City of El Paso – City Plan Commission Staff Report

Case No:	SUSU14-00013 Haciendas Del Rio Unit 1,2 & 3
Application Type:	Major Preliminary
CPC Hearing Date:	March 13, 2014
Staff Planner:	Alejandro Palma, (915) 212-1607, palmaaj@elpasotexas.gov
Location:	North of Borderland and West of Doniphan
Acreage:	91.8279
Rep District:	ETJ
Existing Use:	Vacant
Existing Zoning:	N/A
Proposed Zoning:	R-2 (Residential District)
Nearest Park:	Rio Grande River Trail # 1 (.30 miles)
Nearest School:	Jose H. Damian Elementary (.90 miles)
Park Fees Required:	N/A
Impact Fee Area:	N/A
Property Owners:	County of El Paso; Haciendas el Rio Partners L.P.
Applicant:	CAD Consulting
Representative:	CAD Consulting

Haciendas Del Rio Unit 1,2 & 3

HACIENDAS DEL RIO
UNITS 1, 2, 3
BEING TRACTS 3B, 3C, 3D1 AND A 30 FOOT COUNTY ROW,
BLOCK 16, AND TRACTS 1B AND 1C, BLOCK 13 OF
EL PASO COUNTY, TEXAS, CONTAINING 91.8279 ACRES
PRELIMINARY PLAT
UNIT 2
GRAPHIC SCALE
SCHOOL DISTRICT
TOTAL RESIDENTIAL LOTS
228
HACIENDAS DEL RIO
PREPARATION DATE: 01-20-14

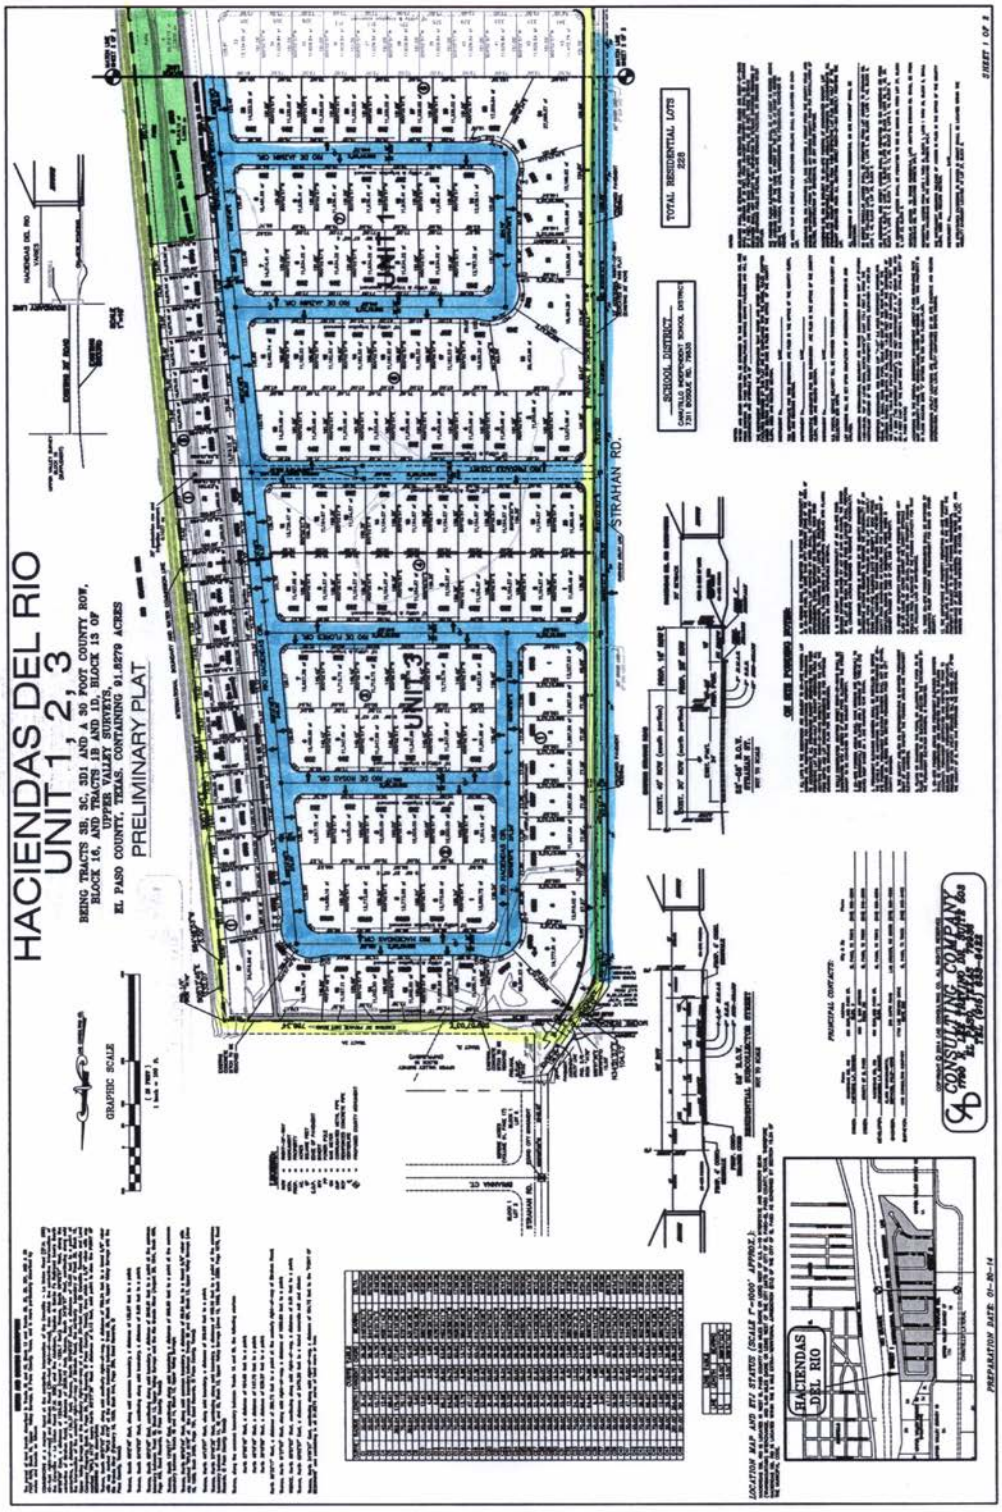
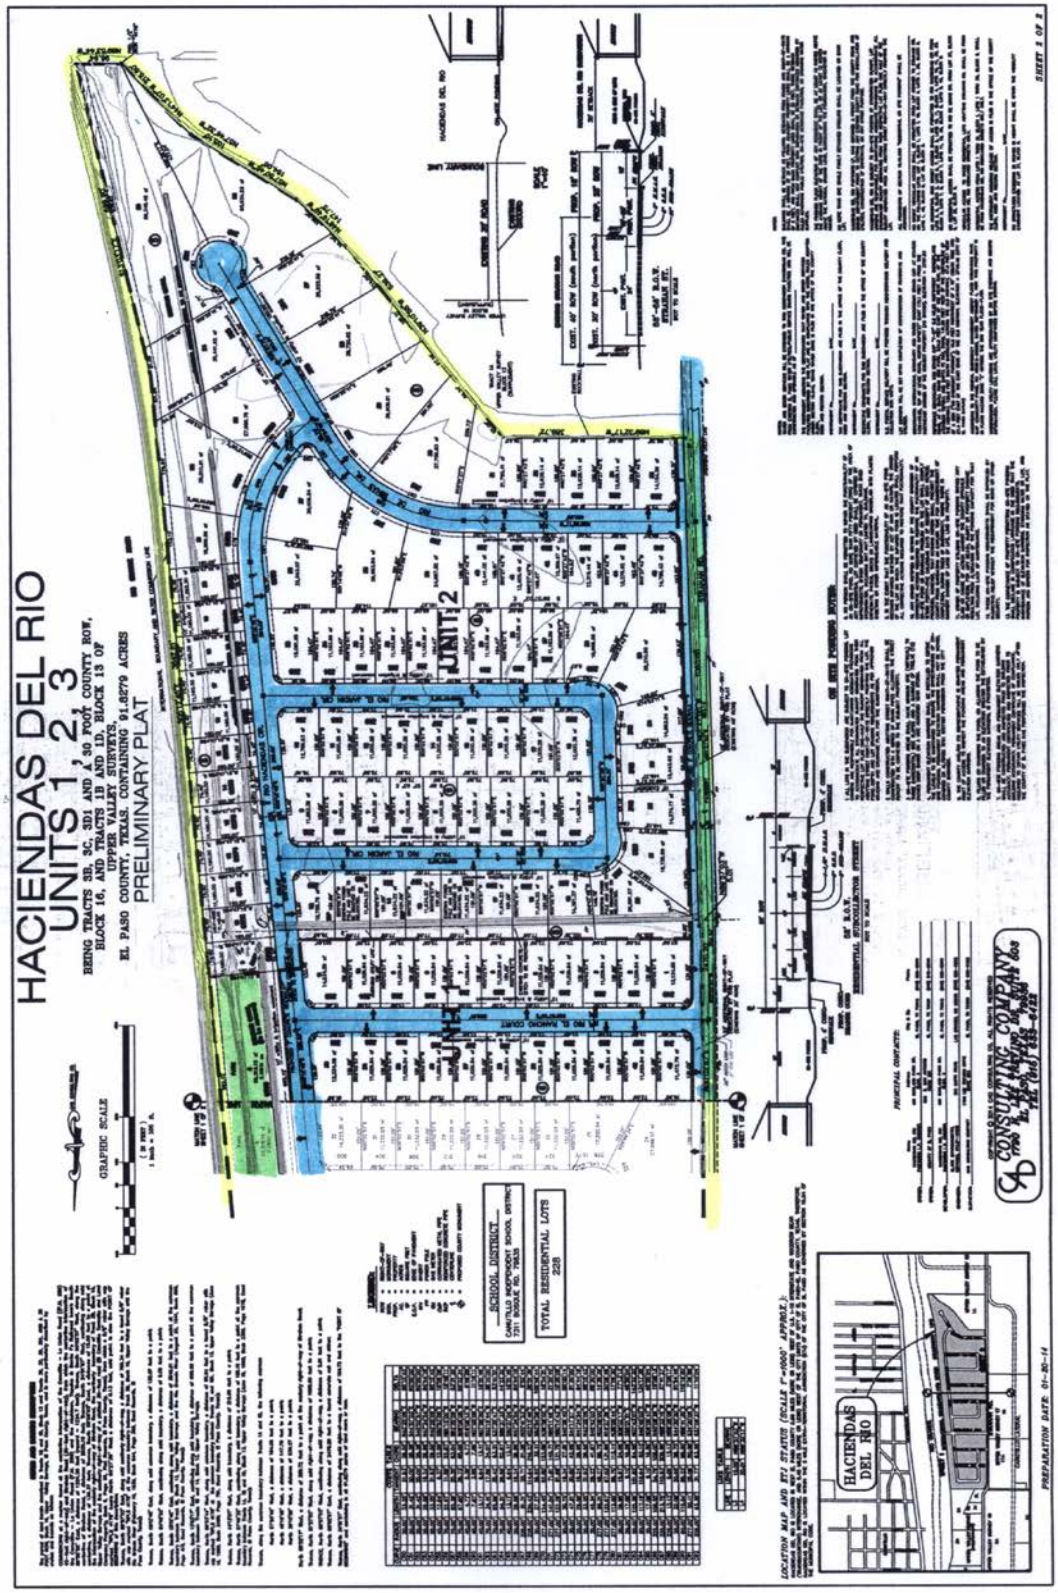
The Development Coordinating Committee recommends **approval** of the modifications and **approval** of Haciendas Del Rio Units 1, 2 & 3 on a Major Preliminary basis, subject to the following requirement:

- That the City Plan Commission require the applicant to landscape the parkway at the rear of all double frontage lots along Strahan Rd.

We have reviewed **Haciendas Del Rio Unit 1, 2, 3** a major preliminary plat map and offer no objections to this development; however, we offer Applicant / Developer the following comments:

1. Park improvements shall include as previously agreed the following at minimum: Grading, leveling, sidewalks fronting the street & all around the park's perimeter, turf & irrigation, playground equipment, swings and canopy for the playground equipment.

*The Haciendas Del Rio subdivision plans presented for this review are similar to the set of plans provided by the Developer on November 15, 2012. This plan however, designates Phase One as **Unit One**, Phase Two as **Unit Two**, and Phase Three as **Unit Three**.*

The phasing plans provided by the developer on November 15, 2012 depict the boundary line between Phase One and Phase Three inside Lot 29, Block One (1), Haciendas Del Rio subdivision. For the purpose of designating individual water and sanitary sewer service contracts for each lot, EPWU-PSB included Lot 29, Block One (1), Haciendas Del Rio subdivision into Phase Three. Lot 30, Block 1, Haciendas Del Rio subdivision remained in Phase One.
